Addendum 6 to the CP-HPS2 2010 FEIR

Addendum Date: October 1, 2019
Case No.: 2007.0946E
Project Title: Candlestick Point–Hunters Point Shipyard Phase II
Development Plan Project
EIR: Certified June 3, 2010
Project Sponsor: CP Development Co., LLC
Lead Agency: Office of Community Investment & Infrastructure
OCII Staff Contact: José Campos – 415.749.2554
jose.campos@sfgov.org
City Staff Contact: Joy Navarrete – 415.575.9040
joy.navarrete@sfgov.org

FIGURE 2 Addendum 6 to the CP-HPS2 2010 FEIR
2010 PROJECT LAND USE PLAN

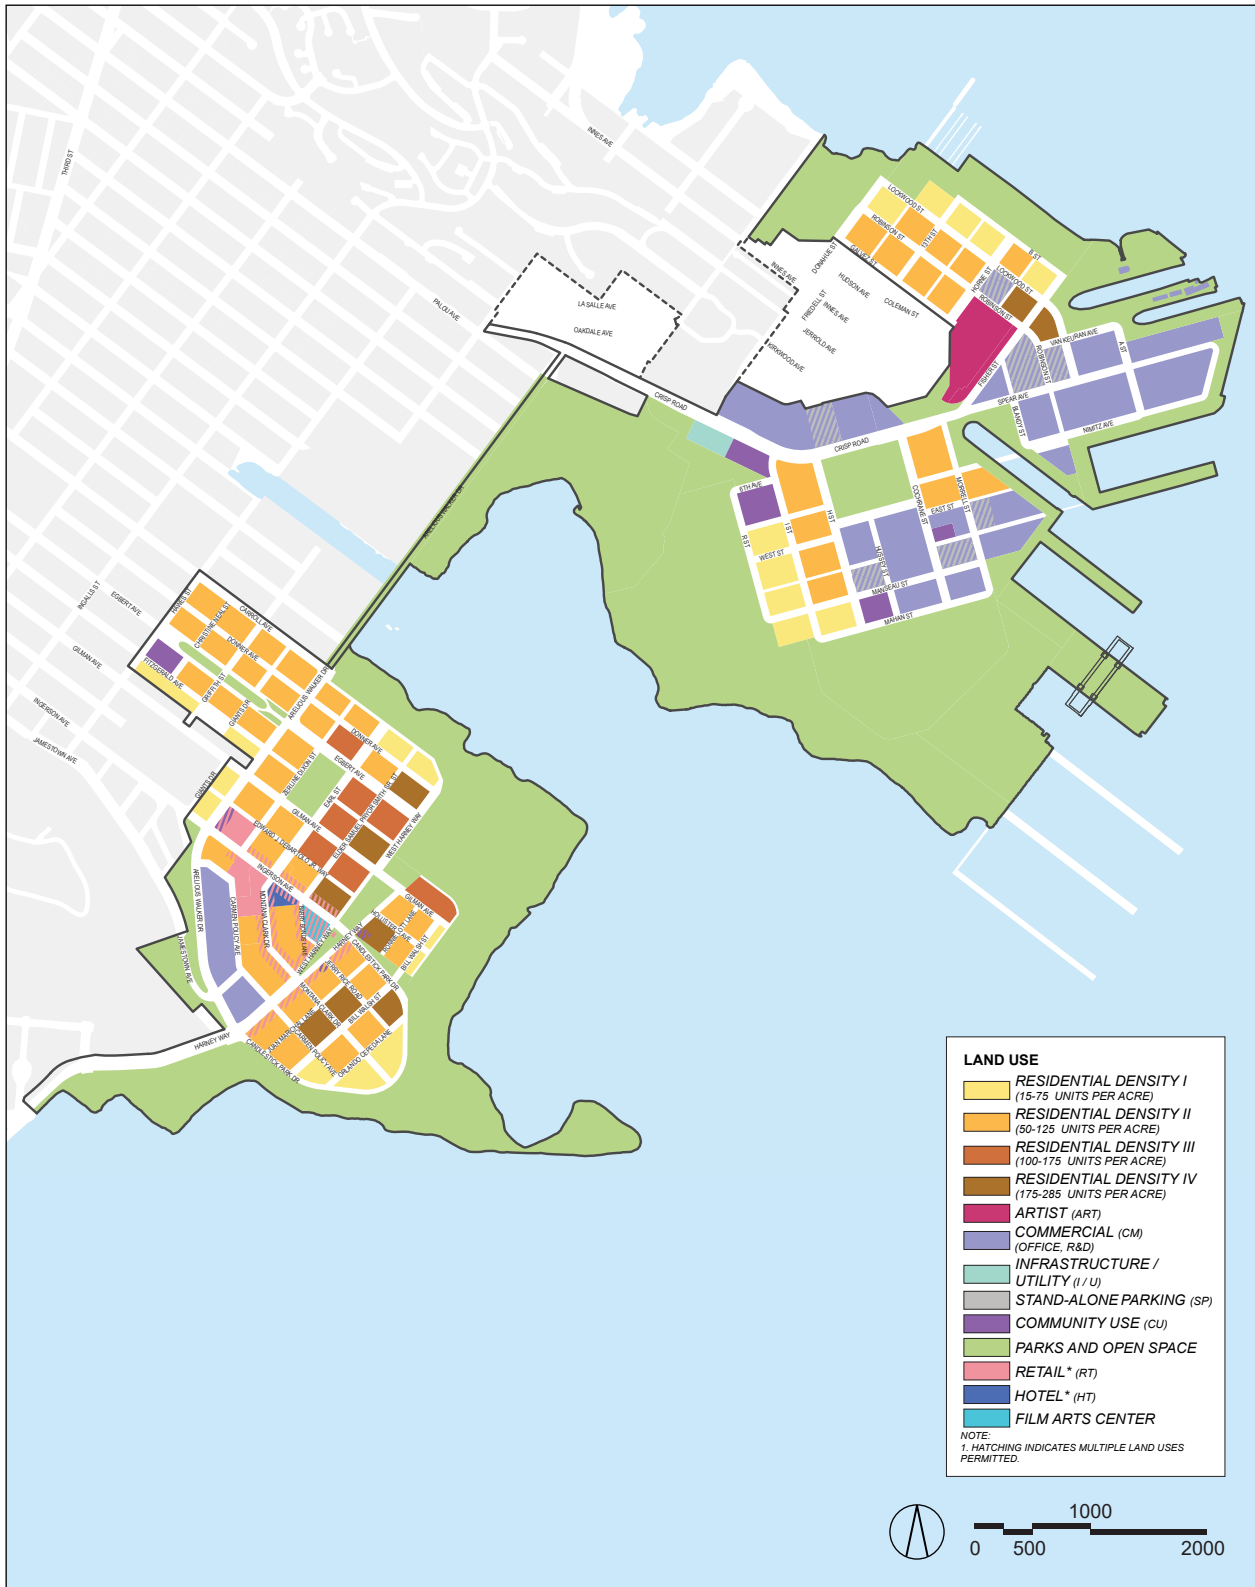
Figure 2 (2010 Project Land Use Plan) illustrates the arrangement of land uses under the 2010 Project, and Figure 3 (2019 Modified Project Variant Land Use Plan) illustrates the arrangement of land uses under the 2019 Modified Project Variant.

Addendum 6 to the CP-HPS2 2010 FEIR
2019 MODIFIED PROJECT VARIANT LAND USE PLAN

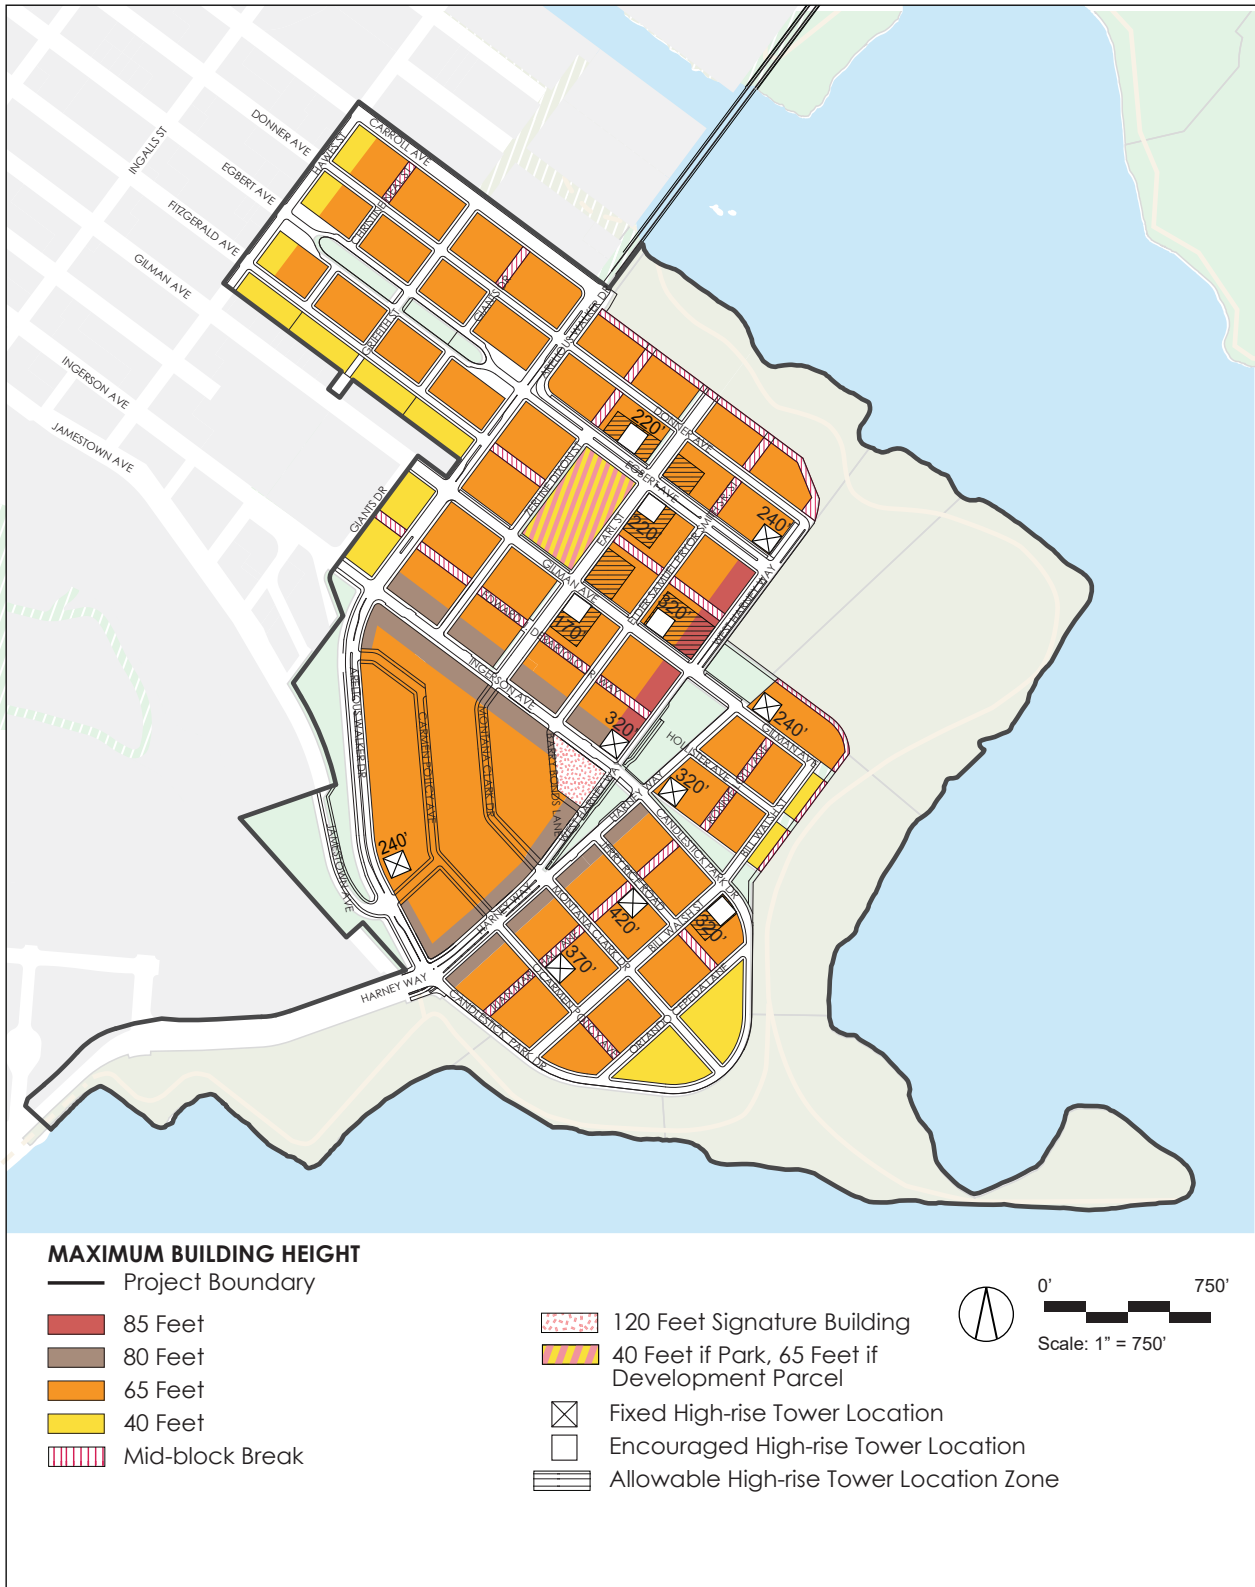
CP-02 is generally divided into two distinct development areas that are separated by Montana-Clark Drive, which runs north to south through CP-02 (refer to Figure 3, 2019 Modified Project Variant Land Use Plan, p. 13). To the west of Montana-Clark Drive in CP-02, uses would include 1,000,000 sf of R&D/office, approximately 579 dwelling units, approximately 76,000 sf of regional retail, and 1,000 sf of community space. To the east of Montana-Clark Drive, uses would include a 130,000 sf hotel, approximately 419 dwelling units, approximately 94,000 sf of regional retail, and a 64,000 sf film arts center. For purposes of the transportation analysis for the 2019 Modified Project Variant, the performance venue is assumed to be located in CP-02.

Addendum 6 to the CP-HPS2 2010 FEIR
2016 APPROVED CP MAXIMUM BUILDING HEIGHTS

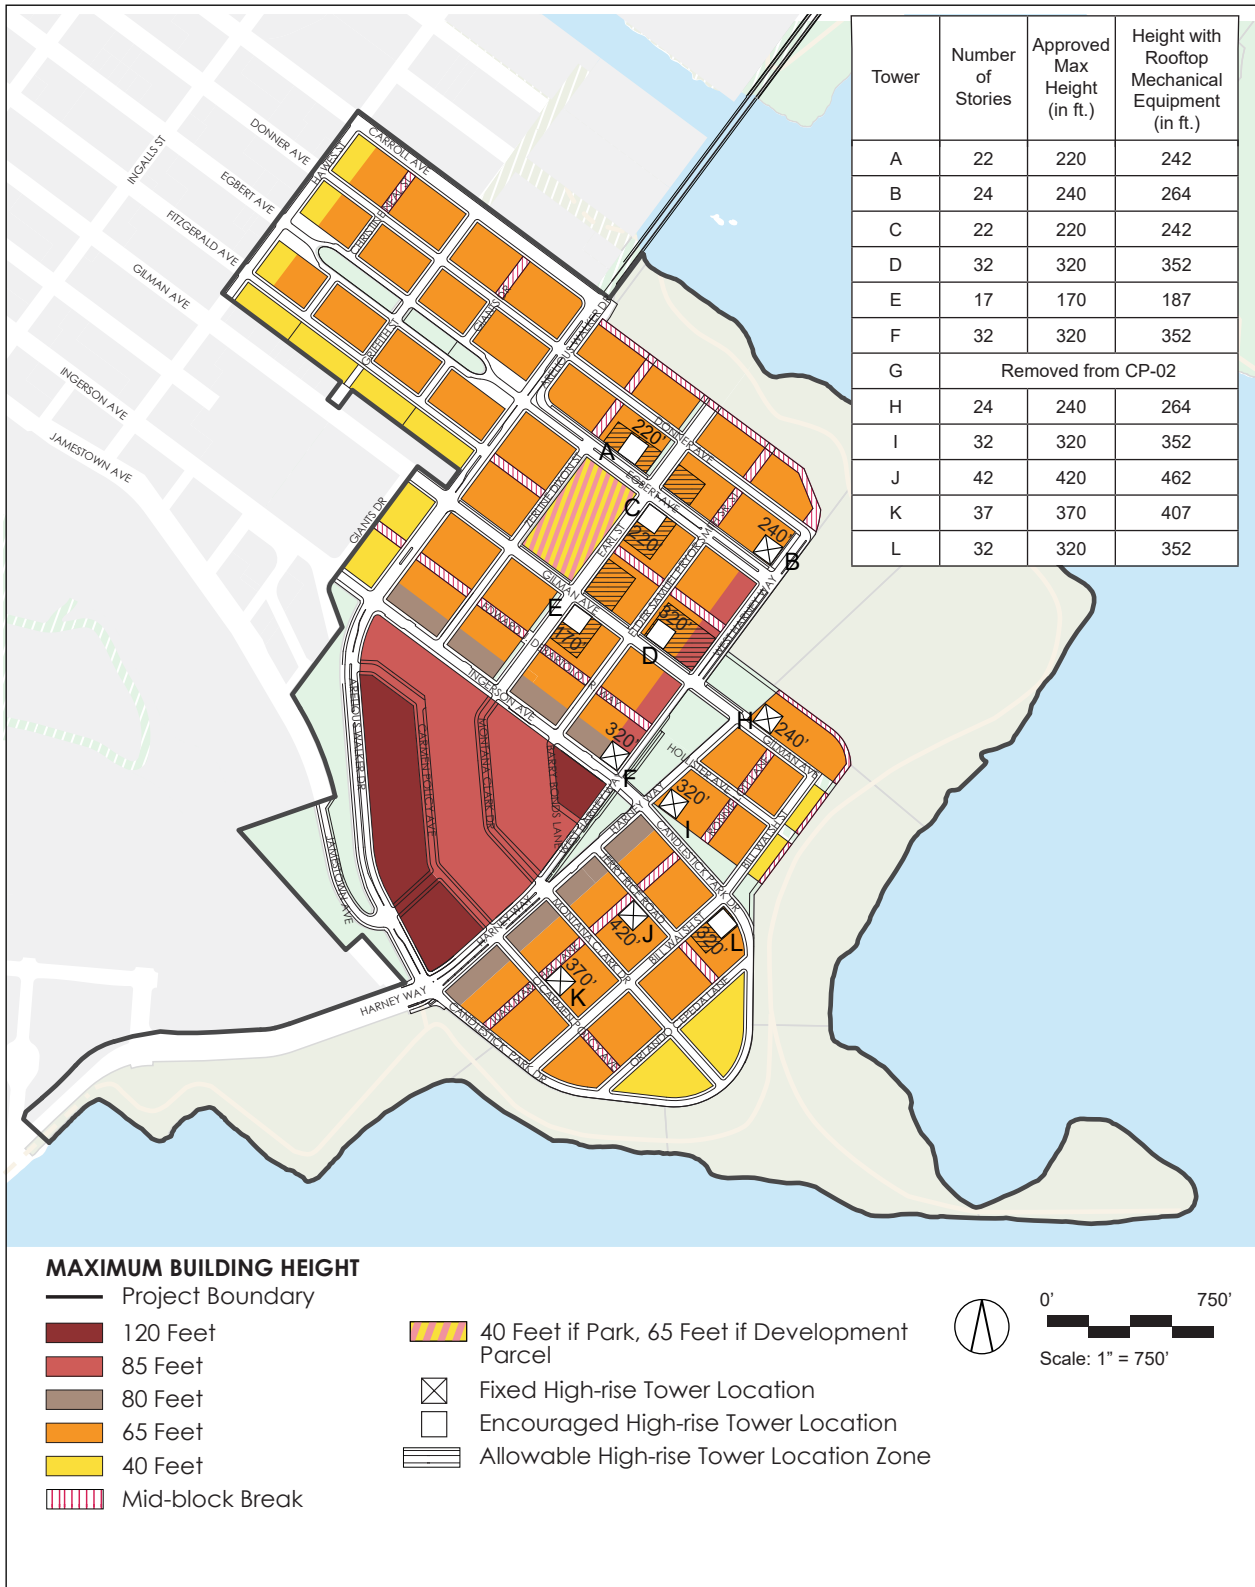
Figure 4 (2016 Approved CP Maximum Building Heights) shows the allowable heights at CP allowed under the 2016 approvals, and Figure 5 (Proposed 2019 CP Maximum Building Heights) shows the proposed height of buildings at CP under the 2019 Modified Project Variant.

FIGURE 7  Addendum 6 to the CP-HPS2 2010 FEIR
CENTRAL ENERGY PLANT EQUIPMENT LAYOUT

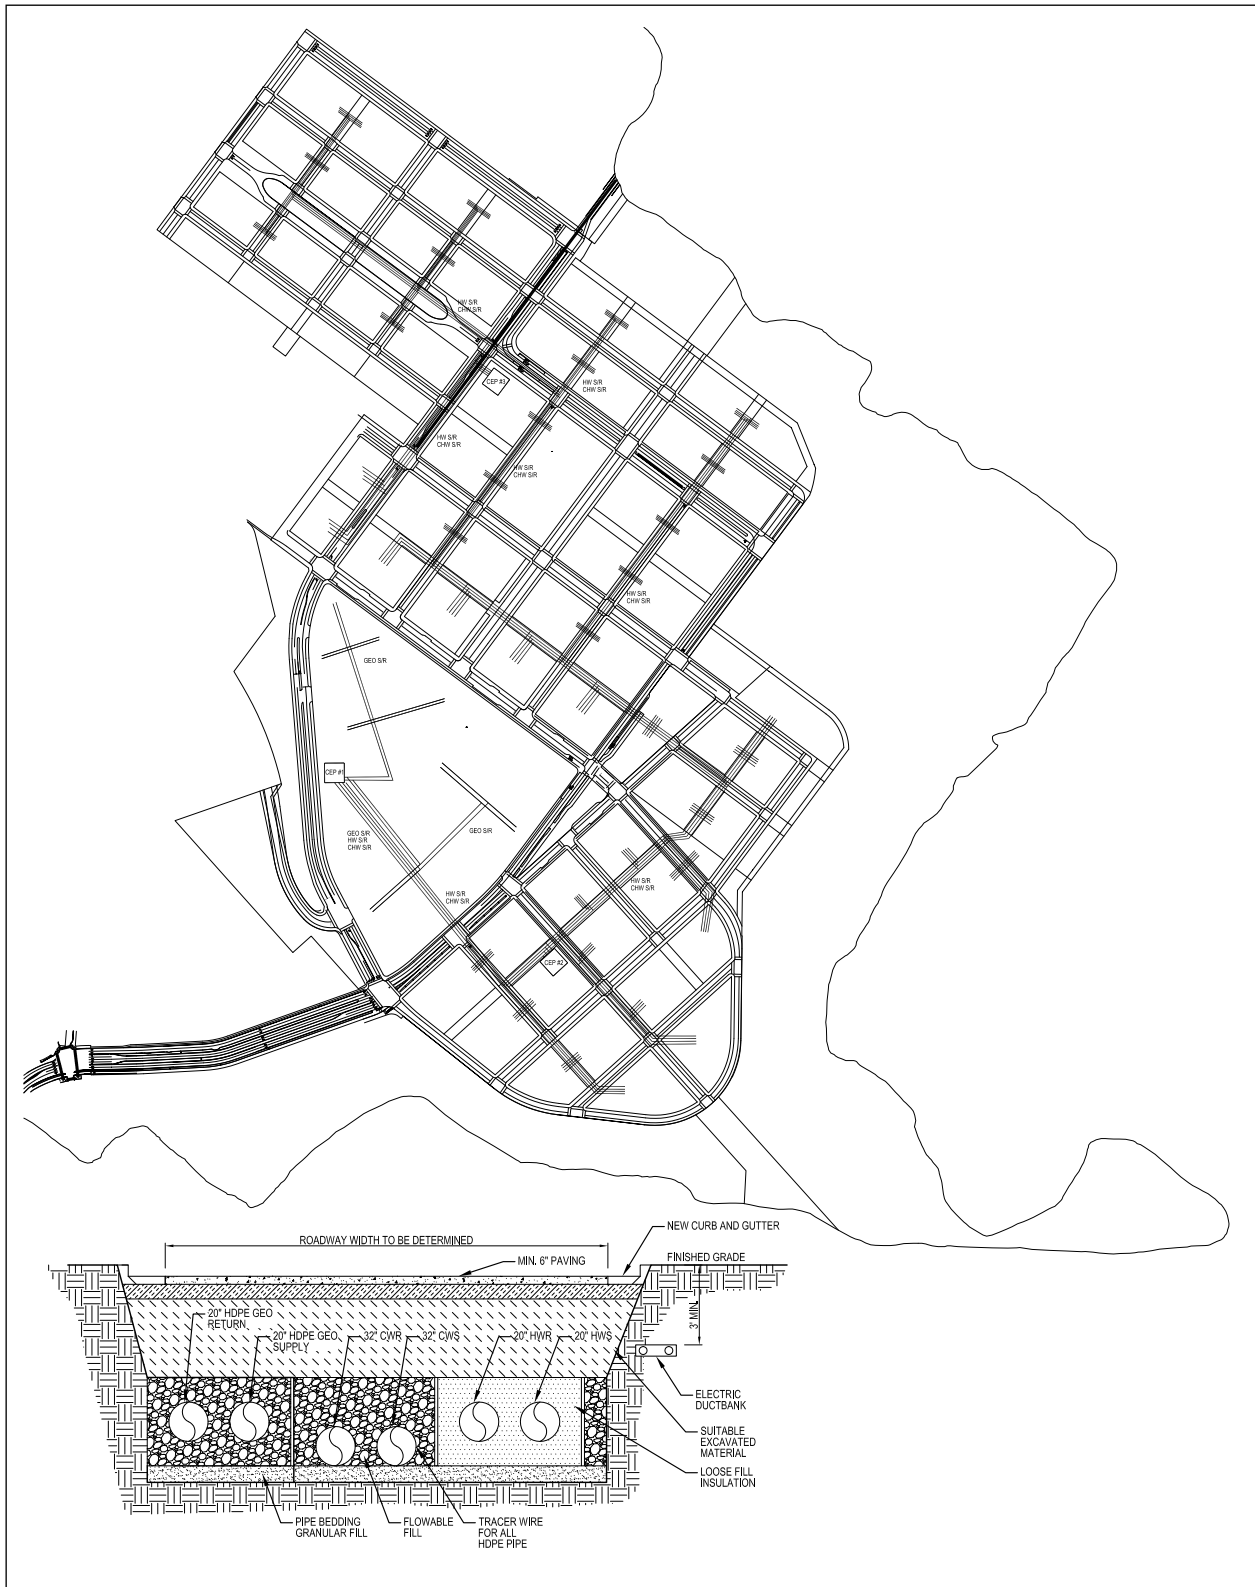
Figure 7 (Central Energy Plant Equipment Layout) shows how equipment may be configured within the CEP. The layout of the geothermal distribution system throughout CP is illustrated by Figure 8 (Mechanical Geothermal Plan), Figure 9 (Geothermal Heating and Cooling System: Commercial) provides a conceptual depiction of the type of geothermal heating and cooling system proposed for commercial uses at CP, and Figure 10 (Geothermal Heating and Cooling System: Residential) provides a conceptual depiction of the type of geothermal heating and cooling system proposed for residential uses at CP.

Addendum 6 to the CP-HPS2 2010 FEIR
29 SUNSET TRANSIT ROUTE CHANGE

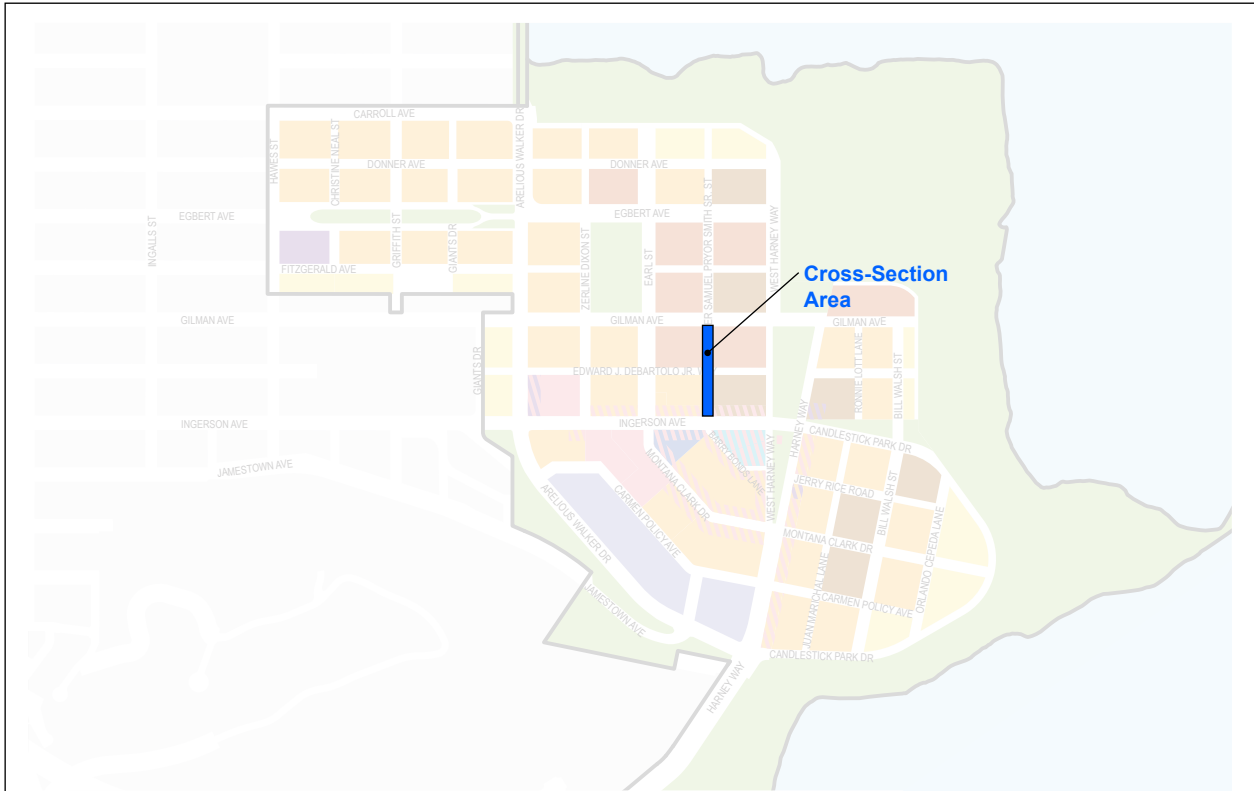
The 2019 Modified Project Variant proposes to modify the 29 Sunset route internal to the Project site. As illustrated in Figure 14 (29 Sunset Transit Route Change), p. 65, the 29 Sunset currently uses Gilman Avenue to Earl Street to Ingerson Avenue to enter the Project site. The modified Project proposes to move the route from Earl Street to Elder Samuel Pryor Smith Senior Street between Gilman Avenue and Ingerson Avenue.

FIGURE 15

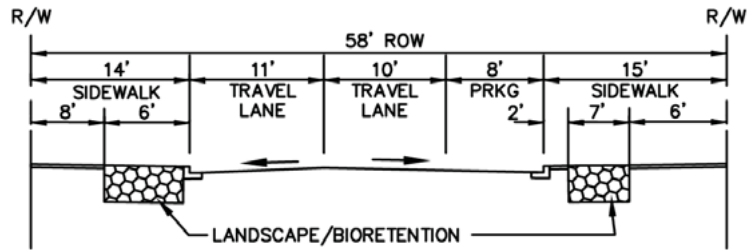
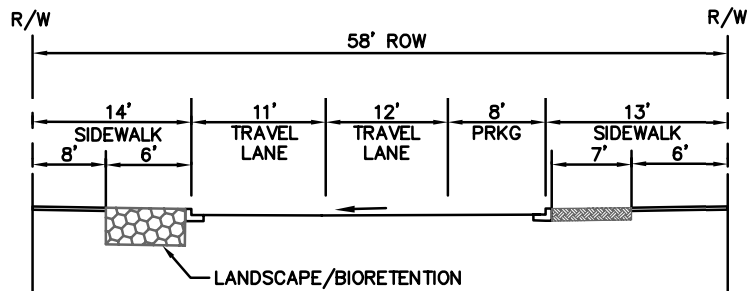
The 2019 Modified Project Variant includes refinements to roadway cross-sections, including Elder Samuel Pryor Smith Senior Street and an off-site segment of Harney Way. The cross-section at Elder Samuel Pryor Smith Senior Street would be revised to accommodate a shared auto/bus lane in the southbound direction, as required by the 29 Sunset re-route previously described. In addition, on-street parking would be relocated from the east side of the street to the west side of the street, as illustrated in Figure 15 (Elder Samuel Pryor Smith Senior Street Cross-Section Modification), p. 66.
